DATE: October 2, 2015
TO: Board of Appeals
FROM: Planning Board
RE: Revised Site Plan for a Medical Marijuana Dispensary at
160 Washington Street

Re: 160 Washington Street, Brookline, MA

Date: October 1, 2015

Site Plans for Proposed Site Improvements

SITE PLAN

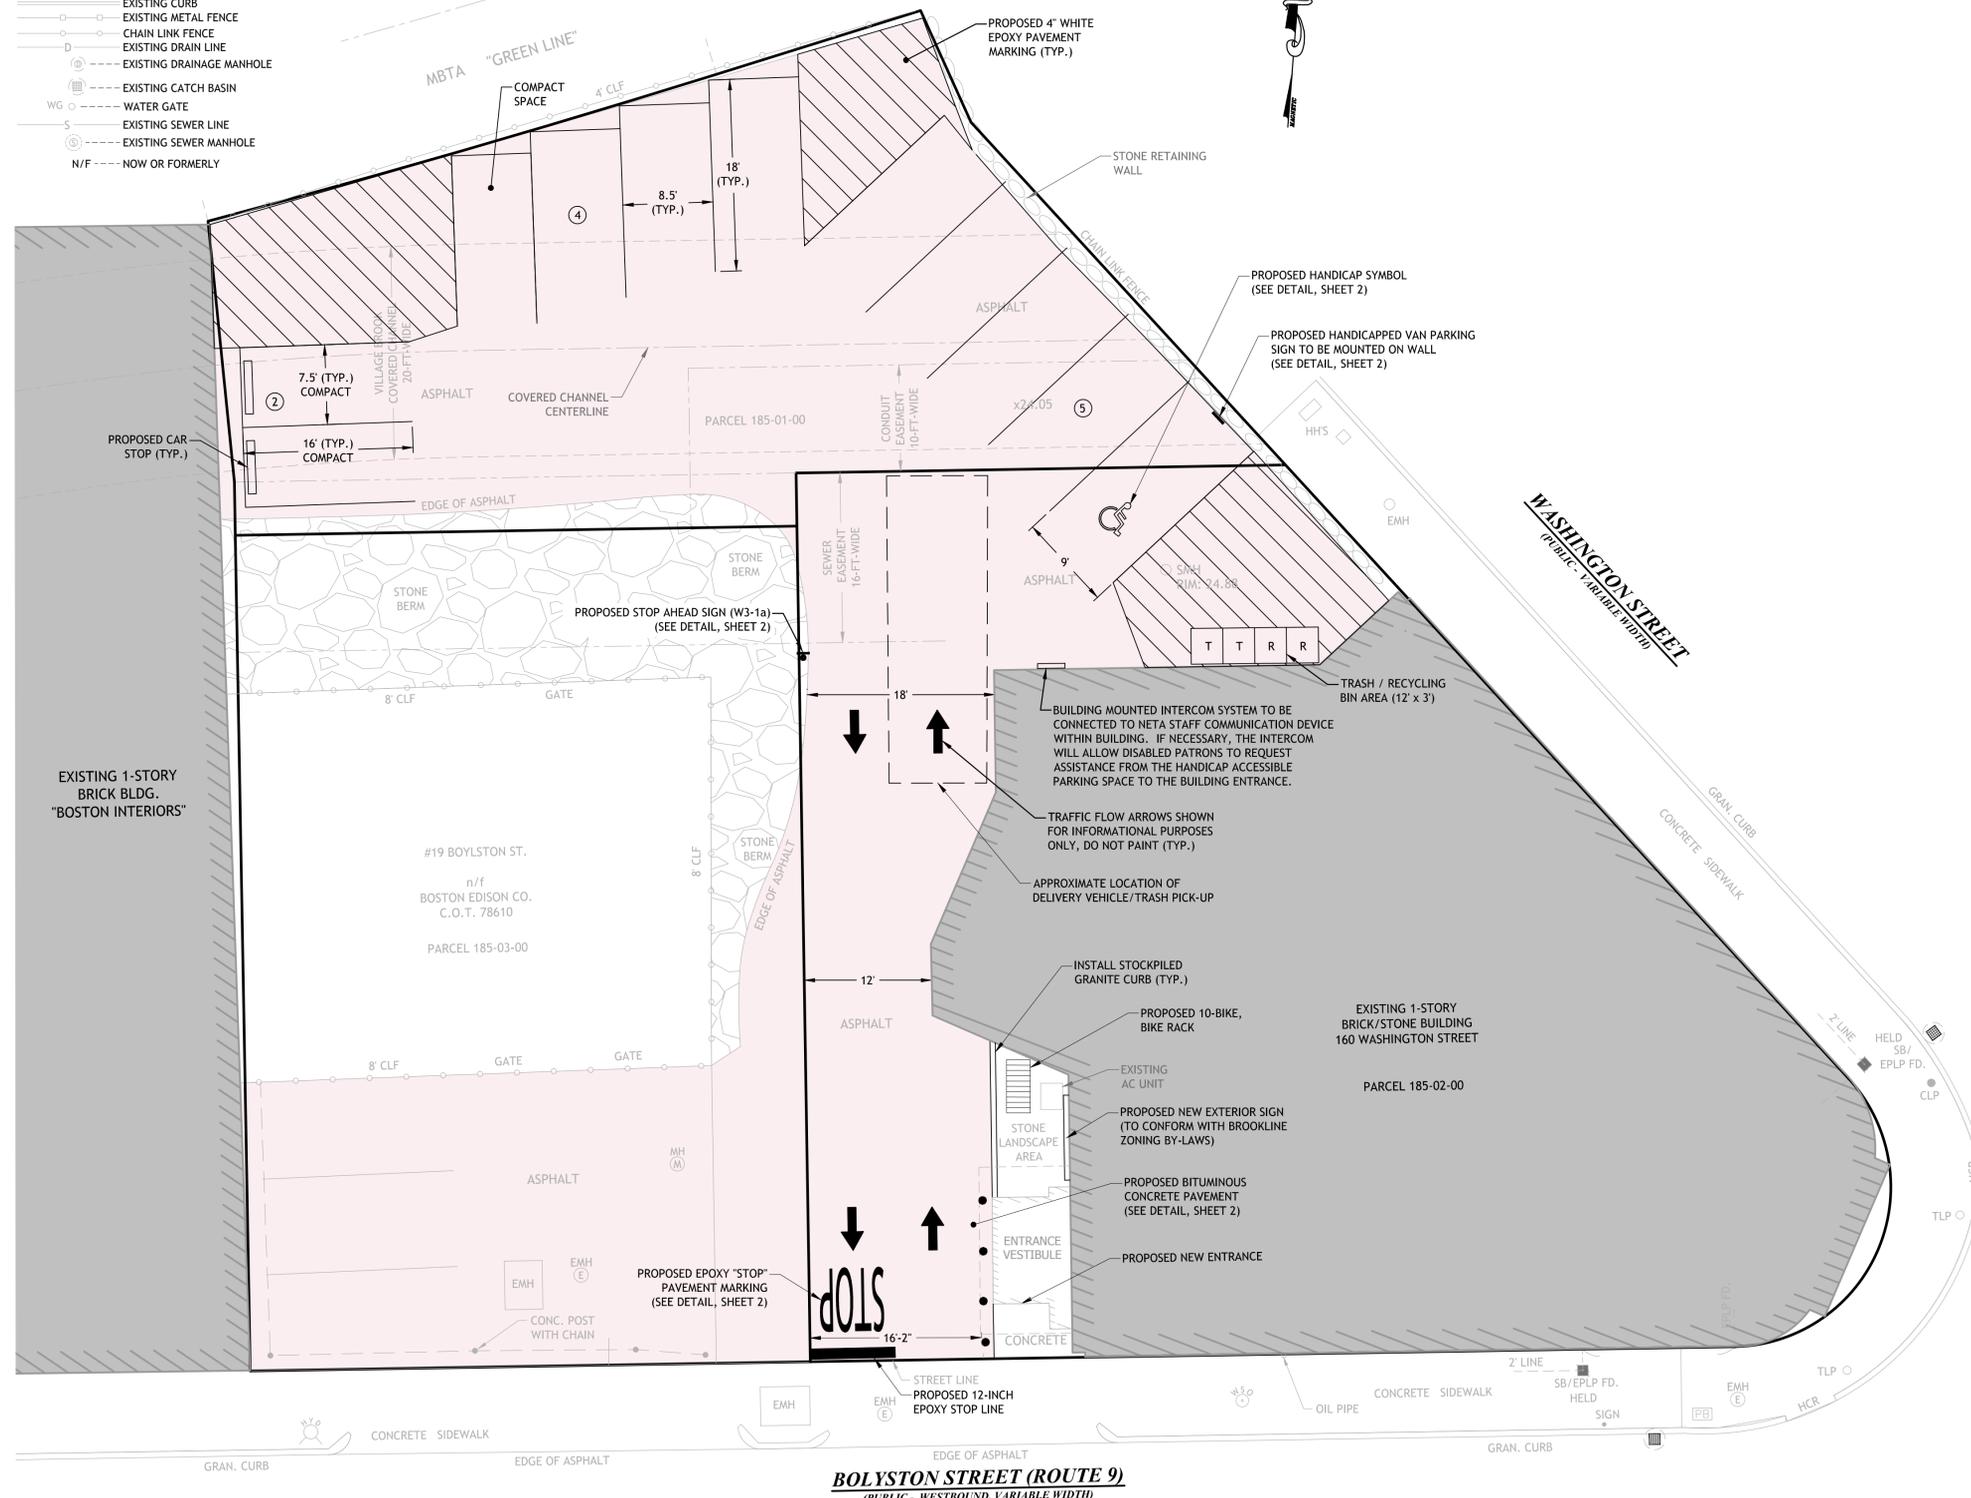
At its September 17th meeting, the Planning Board reviewed NETA's revised site plan for a medical marijuana facility at 160 Washington Street. The Board felt that the current width of the driveway opening would not adequately handle traffic flow to and from Route 9, because at busy times, vehicles would queue on Route 9 while waiting to enter the site. Acknowledging that the driveway is a pre-existing, non-conforming condition, the Planning Board recommended several solutions that would improve safe access in and out of the site and urged the applicant to consider using one or more of the following methods:

- Increase the width of the driveway entrance by modifying the area around the kiosk or the kiosk, itself.
- Have a police officer and an attendant present to direct traffic in and out of the site
- Eliminate the existing on-street parking spaces between the parking lot entrance and Washington Street to provide a safe stacking lane for vehicles waiting to enter the lot
- Continue negotiations with Eversource, the abutting property owner, for a driveway easement to allow widening of the entrance

The final Site Plan (by Casali Engineering Inc. dated September 29, 2015) utilizes the existing single driveway on the former Bank property at a widened dimension that responds to the urging of the Planning Board to achieve at least a 16' driveway width at the parking lot entrance for the purpose of trying to minimize conflicts between entering and exiting vehicles that might cause backups on Boylston Street in front of the Site. By eliminating an existing interior curb and a small raised area adjacent to the outer edge of the pre-existing ATM vestibule, which will house the only patient access into the RMD, the Site Plan widens the drive aisle width at the parking lot entrance from 14' 5" to 16' 2". This improvement allows NETA to maintain at this location the existing bollards which serve to protect the building and the patient entrance vestibule. This is a feasible physical improvement that is within NETA's control as the tenant on the Site.

In consultation with NETA's transportation consultant, Stantec, this improvement allows for a "holding" area where an inbound vehicle can wait for an outbound vehicle to exit the Site. This is valuable when exiting vehicles are traveling past the 12 foot wide pinch point on the Site. This is responsive to the primary concern expressed that the width of the parking lot entrance

would cause a condition where westbound Boylston Street, right-lane traffic must stop to allow a vehicle to exit the Site parking lot. This allows that vehicle "waiting" to enter the Site to get off Boylston Street and clear the westbound right travel lane.

The current site plan includes a widening of the driveway entrance to 16 feet as requested by the Planning Board. Removal of the existing ATM kiosk to accommodate a further widening is not viable as the kiosk is being re-purposed as a weather-protected patient access point to the RMD. It will serve a vital purpose for the safety and convenience of RMD patients. Given that some concerns have been expressed about patients queuing to gain access through the security checkpoint inside the RMD, the patient entrance vestibule is a critical part of the RMD design. The solution that NETA has come up with accomplishes both goals of widening the driveway entrance and providing a safe, interior space for patients entering the RMD.
